NSW INDEPENDENT PLANNING COMMISSION

RIX'S CREEK-EXPERT ADVICE ON THE MINE SCHEDULE AND FINAL LAND FORM

RFQ-NSWIPC-20180627

Report Name:	Rix's Creek – Expert Advice on the Mine Schedule and Final Landform
Report Number:	
Client Name:	NSW Independent Planning Commission
Author:	Michael Buckley
Approved by:	John Buffington
Date Approved:	2/08/2018

Figure 2 - Reduced Disturbed Area in West Pit OOPD

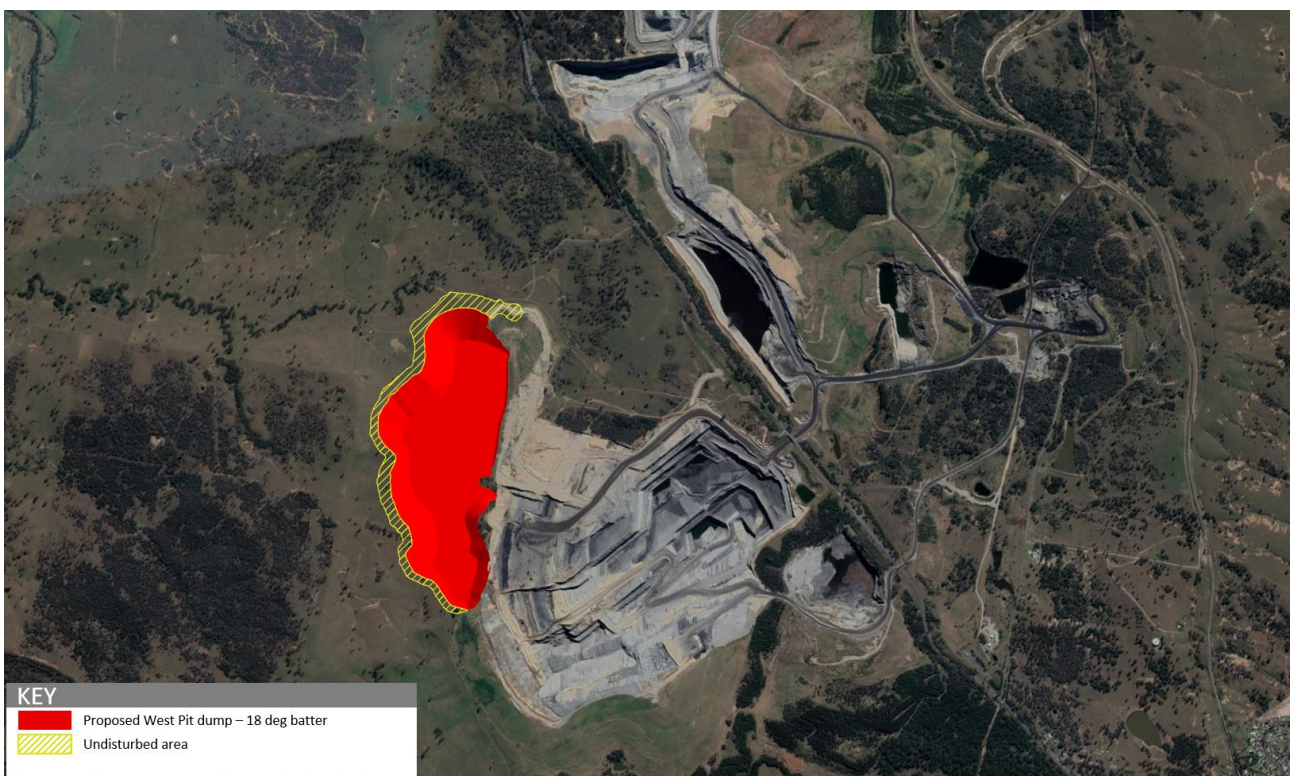
The current West Pit OOPD is designed with a volume of 21M loose cubic metres (lcm) with a final slope angle of 10 degrees, which is defined as “ideal” in the provided key constraints. Increasing the final slope angle to 18 degrees while maintaining the current dump volume would reduce the footprint of the dump from 108 hectares (ha) to 92 ha, thereby reducing the total land area disturbed. Figure 2 shows the potentially undisturbed area (highlighted in yellow, 16 ha) if the final dump slope is increased to 18 degrees.

The proximity of Deadman’s Gully directly to the north of this dump, a range of controls would be required and are subject to further work (landform evolution modelling) to ensure a safe, stable landform is designed and achieved. This modelling was out of scope for our analysis.

1. Landform evolution modelling is conducted to ensure a safe, stable landform is designed and achieved for the increased slope angle of the West OOPD.
2. A tradeoff study is conducted to evaluate the North Pit Dump height options with respect to re-disturbance of previously rehabilitated area and haulage costs.
3. Further investigation is conducted to quantify the actual reduction in final void by removing the two recommended areas from the mining schedule. The effect on the project extraction rates should also be assessed.
